**Re: Residual Maintenance ([PR#38-2023](#))
USFS Wyeth Campground (PWS ID# 41-[94014](#))
Final Approval**

Project Description

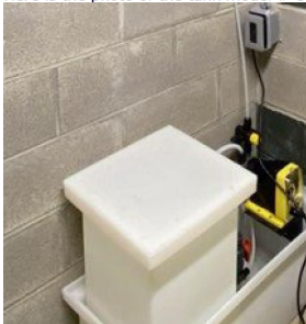
Do you have documentation demonstrating they are currently certified to ANSI/NSF Standard 61?

NSF, Underwriters Laboratories (UL), and Water Quality Alliance (WQA) all can certify products to NSF-61, but these tanks do not have any marking on them to show this. Here is the photo of the tank model # CFSM 15 that was installed.

That is correct these don't have the marking but attached is the documents for the resin used. I'll pass it along since they are our customer.
